DESIGN REVIEW BOARD CONCEPT REVIEW

Design Review Board Case # 2022-0001
Carlyle Block C Rooftop Amendment – 1940 Duke Street

| Application | General Data | |
|---|-------------------------|---|
| Purpose of Application: Concept review of the overall appropriateness of the project’s height, mass, scale, form, and general character for a 3,114 gross square foot rooftop addition at 1940 Duke Street, Carlyle Block C. | | |

Figure 1. Bird's Eye View of Penthouse Addition

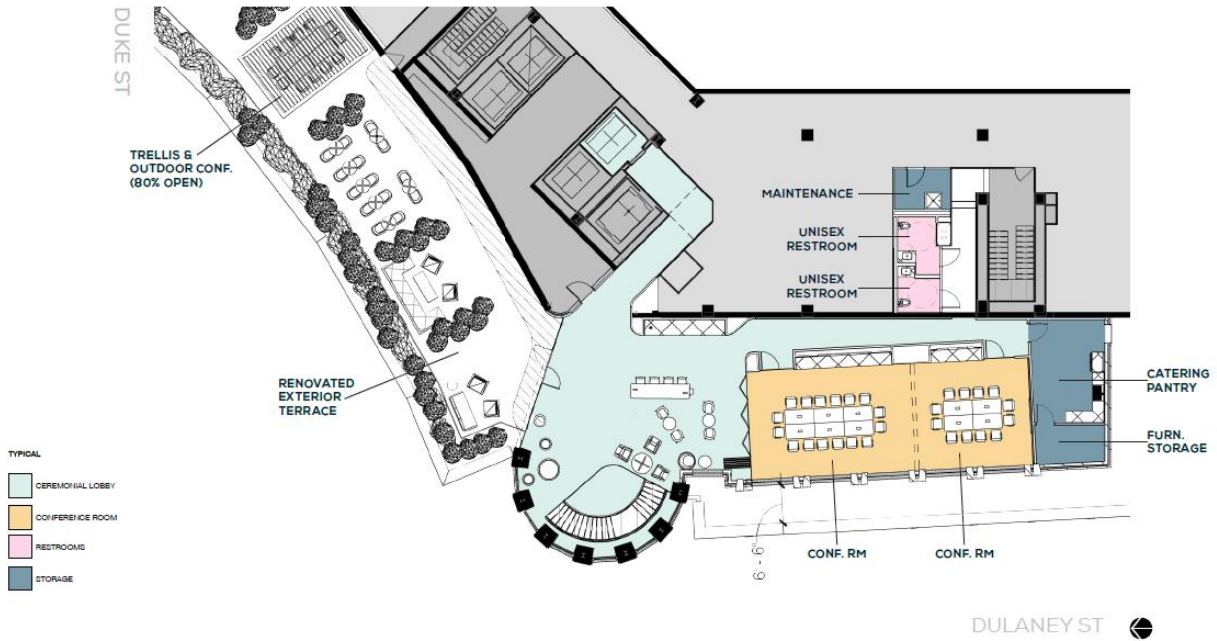
The form and massing of the existing building is intended to mirror the crescent shaped Time Life building across Dulaney Street, which together create a grand gateway entry into the Carlyle neighborhood. The Applicant's proposed rooftop addition detracts from that in a number of ways: first by introducing a much simplified and new architectural vocabulary to the façade, second by adding a very heavy and strongly-colored cornice element that appears out of place in the context of both buildings, and most seriously by blocking off the intricate open-work that give the tops of both towers their distinctive character.

- Staff does not support the projecting bulkhead (with the red band) currently shown running along the Dulaney side of the boardroom and wrapping around the south end of it. The

proposed red roof form of the board room and the red architectural feature on the left (east) side of the tower have no relationship to the existing building and are completely out of place visually. Staff recommends removing these items from the design and provide a design for the top of the new boardroom wall similar to the existing roof [parapet/cornice](#) form of the floor below. With the removal of red roof form, staff also recommends extending the height of the board room windows.

- The change to the existing tower eradicates the original open-work tower top design, which is the most iconic part of the building and the Carlyle gateway, and the architectural relation to the main office building canopy on the first floor. Staff strongly recommends limiting any proposed enclosure of the existing tower openings to deeply recessed glass and leaving the detailed soffit, cast stone sills and all other existing trim exposed. Staff does not take exception to the solid enclosure of the circular tower roof top.

Figure 4. View from Duke Street Overpass Heading East

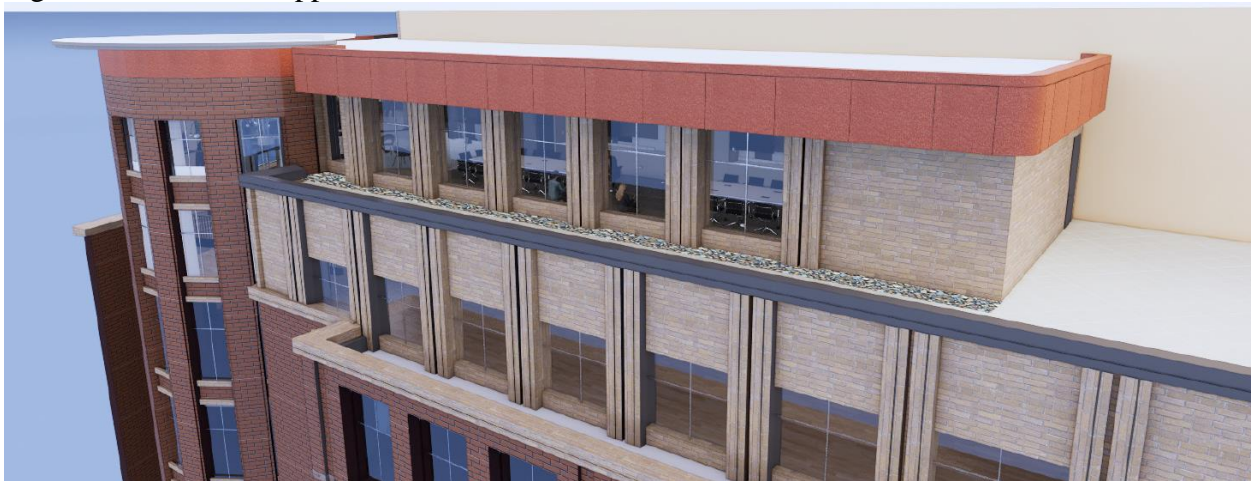
The rooftop addition will not be very visible from the pedestrian realm on Dulaney Street but will however be very visible from nearby areas. The Carlyle neighborhood is at geographic low point compared to the land to the north, which is especially elevated around the George Washington Masonic Memorial. From the memorial and other nearby areas, the Applicant's proposal rooftop addition will be clearly in viewable. Therefore, it is especially important the addition tie into the existing building. The visual importance of the architectural expression of this (admittedly small) proposed addition is nowhere clearer than in the view one sees when descending from the Duke Street overpass eastbound (see below). From that vantage point, the addition as currently clad introduces a massing and expression that clash with the existing stepped massing and language.
